**Response to Request for Additional Information**  
**Generic Letter 2004-02**

**Surry Power Station Units 1 and 2**

**VIRGINIA ELECTRIC AND POWER COMPANY**  
**(DOMINION)**

In a letter dated June 18, 2009, the Nuclear Regulatory Commission (NRC) transmitted a request for additional information (RAI) regarding Dominion's February 29, 2008 and February 27, 2009 supplemental responses to GL 2004-02 for SPS 1 and 2. The NRC's questions and Dominion's responses are provided below.

Figure 1 - Test Parameters vs. Time for SPS RS Strainer Test

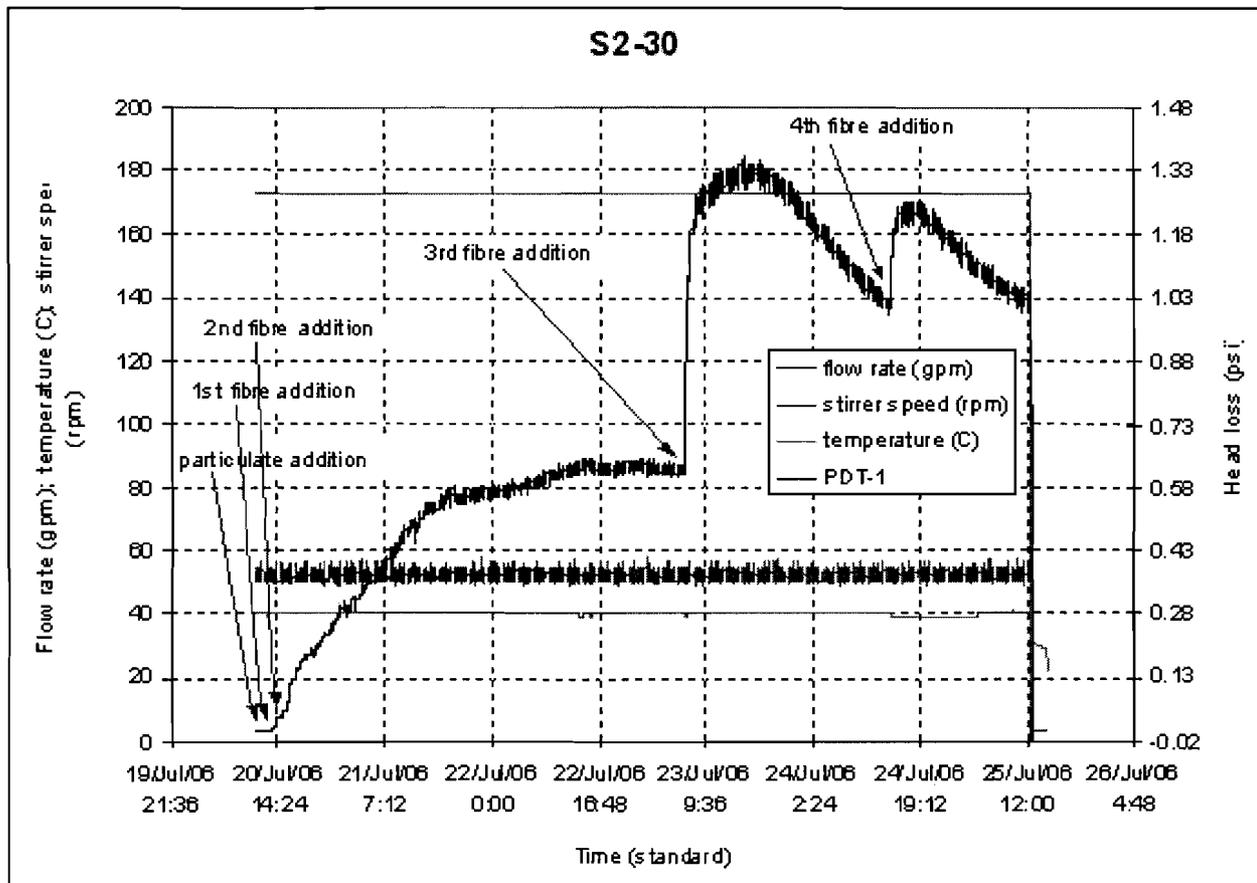
*Please provide additional information that justifies the temperature/viscosity extrapolation of data from test temperatures to predicted loss-of-coolant accident (LOCA) temperatures. Based on recent review of Rig 33 head loss traces for North Anna during the chemical effects audit of that plant, the staff believes that there may not have been "sudden" decreases in measured head loss, but there were anomalous observations of fairly large and relatively fast head loss decreases for qualification tests and other non-qualification tests for North Anna. Flow sweeps were done for some of the tests that seemed to indicate that boreholes did not have a significant influence on the temperature scaling. However, the staff does not consider this information sufficient to conclude that there were no signs of potential bed degradation. Please provide results of evaluation of the cause of the decreases in head loss that occurred during testing.*

As shown in Figure 1, the peak RS head loss occurred after the third fiber addition. After that, the head loss was in a slowly decreasing trend for a full day, with no sudden head loss decrease. The fourth fiber addition increased the head loss to 1.2 psi. Again, about 4 hours after the fourth fiber addition, the head loss decreased slowly again. The decreasing trends after the third and the fourth fiber additions were almost parallel, which indicated that the debris bed structure was consistent after the fourth addition.

**Figure 5 - Head Loss vs. Time during SPS LHSI Chemical Effects Test**

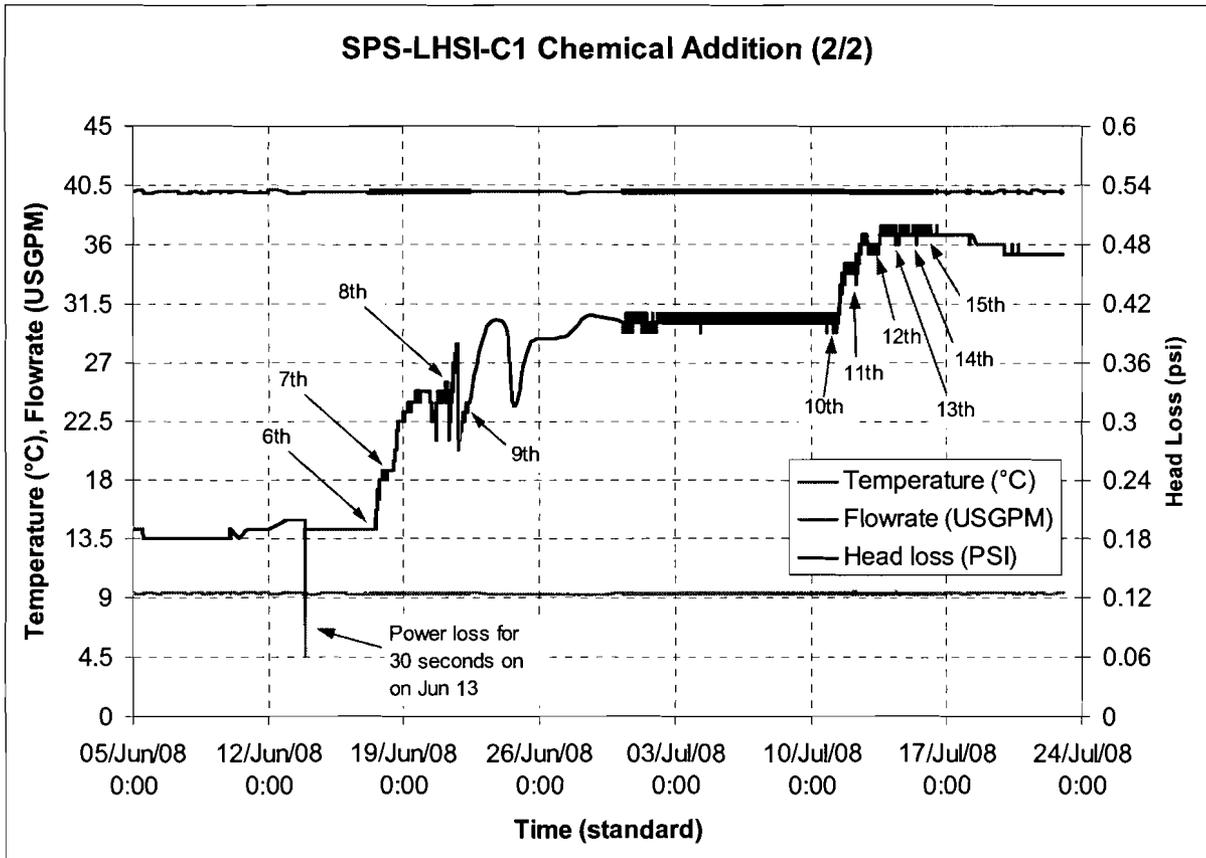
*Please provide an evaluation of the head loss fluctuations that occurred during the low-head safety injection (LHSI) Rig 89 testing between the 7<sup>th</sup> and 10<sup>th</sup> aluminum additions. Also, please explain why these fluctuations do not invalidate any viscosity corrections imposed on the test data.*

The head loss fluctuation between the 7<sup>th</sup> and the 10<sup>th</sup> aluminum additions during the Surry LHSI chemical effects testing is shown in Figure 5. As observed in the chemical effects tests, aluminum precipitate tended to deposit on the fiber surface and block the pores of the debris bed. At the time the 7<sup>th</sup> aluminum addition was added, the head loss was only 0.24 psi. Since the head loss was low, the debris bed was not tightly compact and it was fragile. As more aluminum precipitates deposited on the fiber surface, a dynamic process of debris bed cracking and self-repairing was initiated, which resulted in the head loss fluctuation. As more aluminum was added to the test tank, the head loss became higher and the debris bed was more densely compact and there was no fluctuation between the 11<sup>th</sup> and the 15<sup>th</sup> additions.

The peak measured head loss in the Surry LHSI strainer chemical effects test is 0.5 psi at 104°F, which occurred after the 15<sup>th</sup> aluminum addition. The long-term acceptance criterion for debris bed plus chemical effects (after subtracting allowance for analytically determined clean strainer head loss) is 1.41 feet of water at 104°F, which is equivalent to 0.61 psi at 104°F. Since the test temperature and the long-term sump temperature is the same, viscosity correction is not performed.
